KILDARE COUNTY COUNCIL

PLANNING DEPARTMENT

Type of Development:	<p>Construction of 73 no. social housing units, estate community building and associated development works.</p> <p>* Kildare County Council launched Part 8 Ref P82021-07 for the development of 73 social housing units and associated works at Fortbarrington Road, Ardrew, Athy, Co. Kildare on 30th November 2021. This Part 8 was subsequently withdrawn and Part 8 Ref P82022-03 for the same development was subsequently launched by Kildare County Council on 1st February 2022. As the development proposed in both Part 8's was the same, following the launch of Part 8 Ref P82022-03 Kildare County Council communicated with each party that made a submission in connection with Part 8 Ref P82021-07 confirming that that submission would also be considered as a submission in connection with Part 8 Ref P82021-07. For that reason, submissions in connection with both Part 8 Ref P82021-07 and Part 8 Ref P82022-03 are recorded in</p>

this submissions report and responses are provided to all submissions received in connection with both Part 8's.
Site address	Fortbarrington Road, Ardrew, Athy, Co. Kildare
Development proposed by:	Housing D

Fig 2 Site Location (shaded in orange)

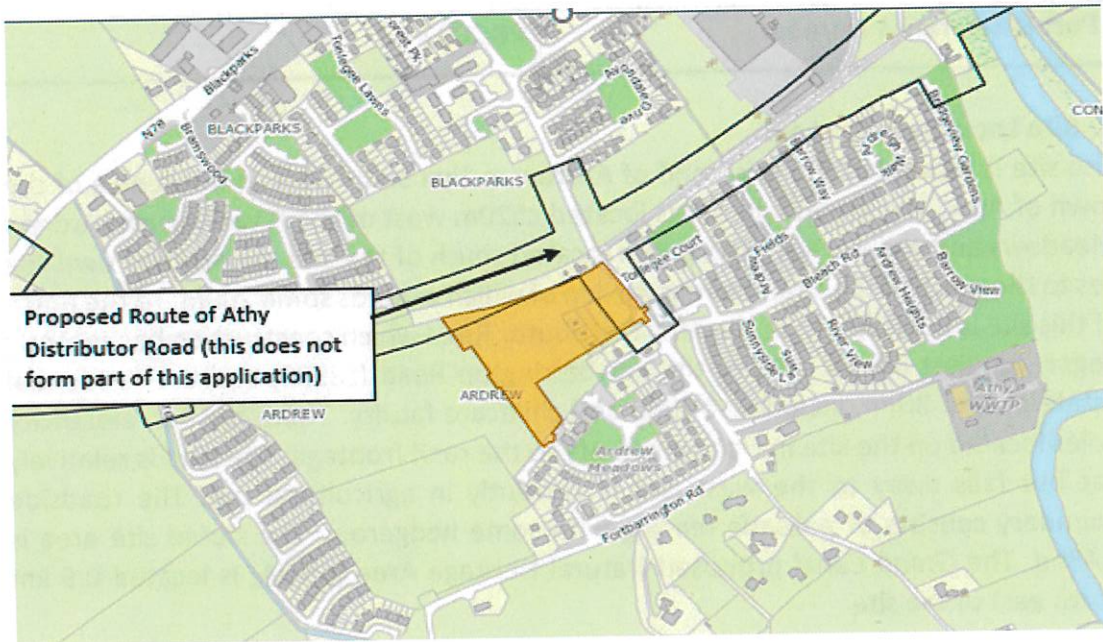
The site is located in the townland of Ardrew, c 1km southwest of the centre of the town of Athy. The greenfield site is located c520m west of the River Barrow. Ardrew Meadows and Ardrew Halting Site are located south of the site. A detached dwelling lies to the north of the site, the rear garden of which extends some 200m. To the north of this site is the location of the Athy Distributor Road which construction has recently begun on. East of the site lies the Fortbarrington Road (L8990) and the residential estate of Dun Brinn, including a shop and childcare facility. There are 3no electricity poles located on the site in close proximity to the road frontage. The land is relatively flat but falls away to the west and is currently in agricultural use. The roadside boundary consists of palisade fencing with some hedgerow. The stated site area is 2.43ha. The Grand Canal proposed Natural Heritage Area (pNHA) is located 0.6 km north east of the site
